UNITED STATES PATENT AND TRADEMARK OFFICE

APPLICATION NO.	FILING DATE	FIRST NAMED INVENTOR	ATTORNEY DOCKET NO.	CONFIRMATION NO.
10/717,843	11/20/2003	Manoj Mehrotra	TI-29199.1	8561
23494	7590	09/16/2004	EXAMINER	
TEXAS INSTRUMENTS INCORPORATED			DIAZ, JOSE R	
P O BOX 655474, M/S 3999			ART UNIT	
DALLAS, TX 75265			PAPER NUMBER	
			2815

Office Action Summary	Application No. 10/717,843	Applicant(s) MEHROTRA ET AL.	
	Examiner José R. Díaz	Art Unit 2815

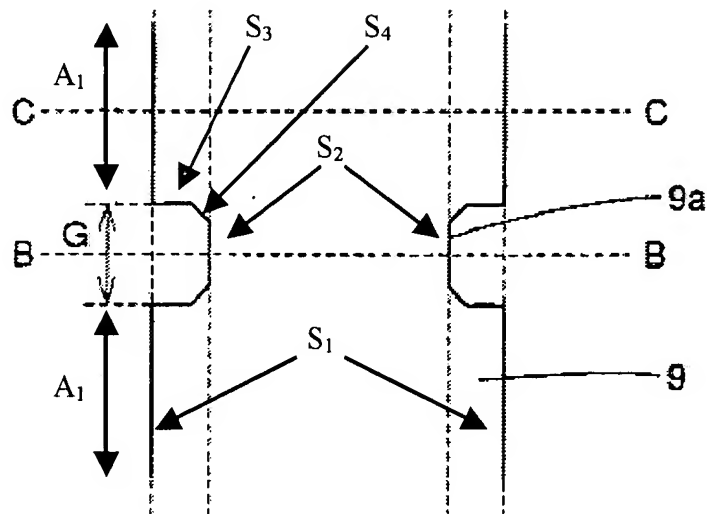
a gate electrode (9) extending along the surface for a length (see fig. 22A), the gate electrode (9) having at least one second section (9a) disposed between adjacent ones of the first sections (9) of the gate electrode (see fig. 22A), the at least one second section (9a) having a width that is narrower than the width of the adjacent ones of the first sections (9) of the gate electrode (see fig. 22C); and

source and drain doped regions (5a1 and 5b1) in the surface, and disposed on opposing sides of the gate electrode (see figs. 22A-22B).

FIG.22A

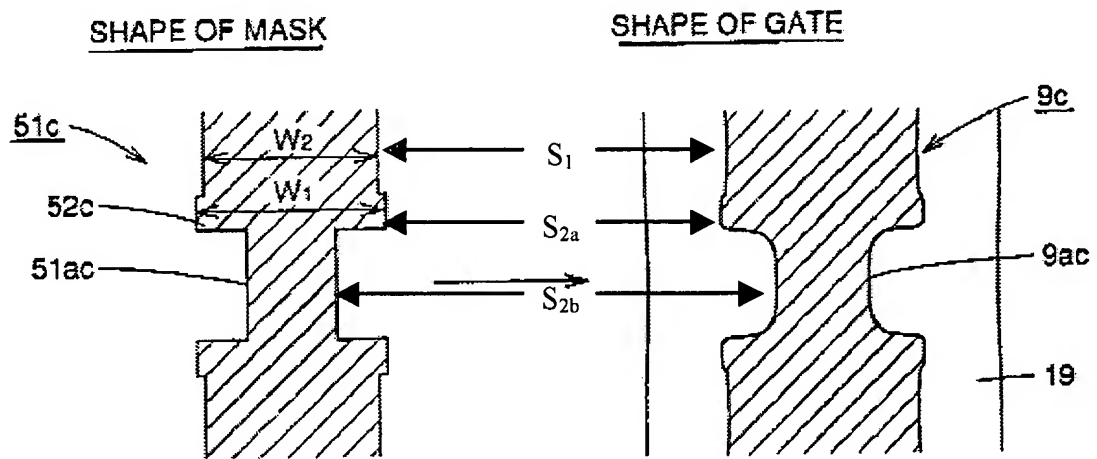
Regarding claim 17, Maeda et al., as far as understood, teaches a device in which the length of the second section (G) is smaller than the length of the first section (A₁) (see figure 22A, below). In addition, the claimed limitations describing the elongated feature of the photoresist contain method of process of making

Regarding claim 18, Maeda et al., as far as understood, teaches that the sides of the second section (S_2) are parallel to the sides of the first sections (S_1), and a side (S_3) formed between first and second sections, which is substantially perpendicular to the sides of the first and second sections (S_1 and S_2) (see figure 22A, above). In addition, the claimed limitations describing the elongated feature of the photoresist contain method of process of making characteristics, therefore given no patentable weight in determining patentability of the final device structure. See case law above.

Regarding claim 20, Maeda et al., as far as understood, teaches that the sides of the second section (S_2) and its adjacent ones of the first sections (S_1) are separated by slopping portions (S_3 and S_4) (see figure 22A, above). In addition, the claimed limitations describing the elongated feature of the photoresist contain method of process of making characteristics, therefore given no patentable weight in determining patentability of the final device structure. See case law above.
